DEPARTMENT REPORT
COMMUNITY DEVELOPMENT DEPARTMENT

HEARING DATE: 9/8/2026
TO: Mayor & City Council
FROM: Bill Parsons, Current Planning Supervisor
208-884-5533
SUBJECT: Adero Park 2
MFP-2026-0007
LOCATION: West of N. Ten Mile Road, north of W. McMillan Road located in SE ¼ of Section 27, T. 4 N., R. 1 W.

Final plat modification to extend a common lot approved with Adero Park Subdivision No. 2 (FP-2025-0030).

B. Proposed Final Plat (dated: 08/05/2026)

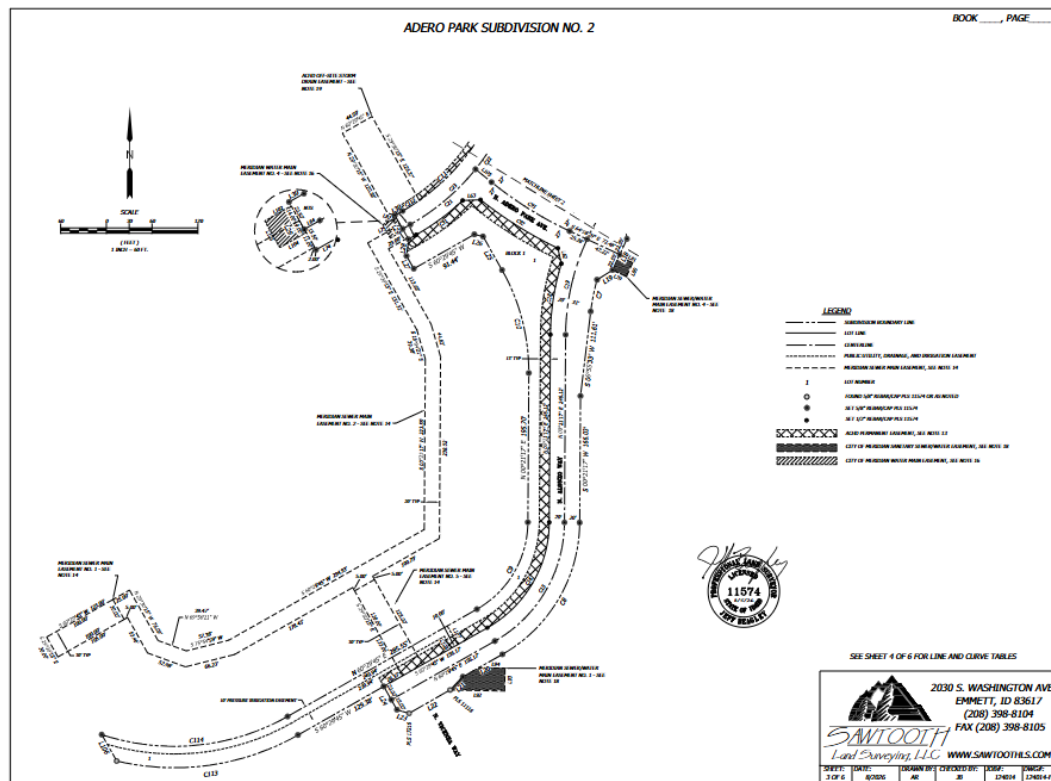
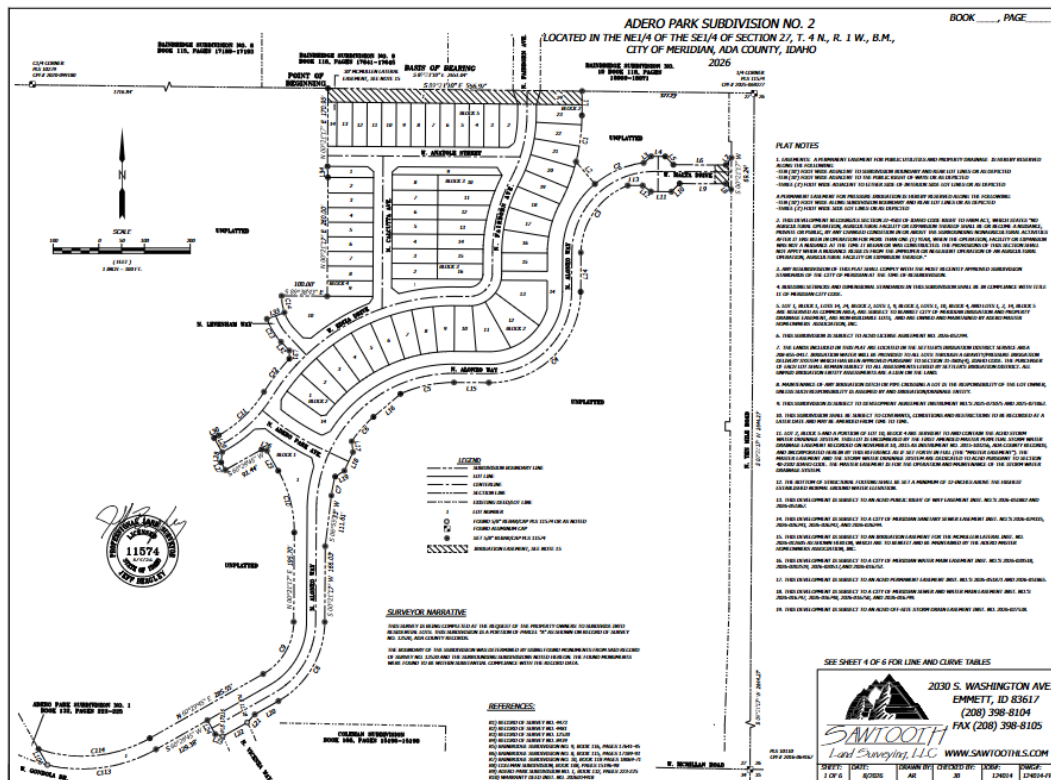
The applicant has submitted an application for a final plat modification to extend the existing common lot (previously Lot 1, Block 5; now Lot 1, Block 1) so that the current phase of the subdivision remains contiguous with the previously approved phase. If the common lot is not extended as proposed, the County Surveyor has indicated that the subdivision would be required to be renamed in accordance with the State Statute.

The proposed final plat modification is necessary to address the County Surveyor's requirements, preserve the subdivision's approved name and allow the applicant to move forward with obtaining the City Engineer's signature on the final plat.

3. Prior to submittal for the City Engineer's signature, have the Certificate of Owners and the accompanying acknowledgment signed and notarized.
4. The final plat prepared by Sawtooth Land Surveying, dated: 08/05/2026, is approved as submitted.
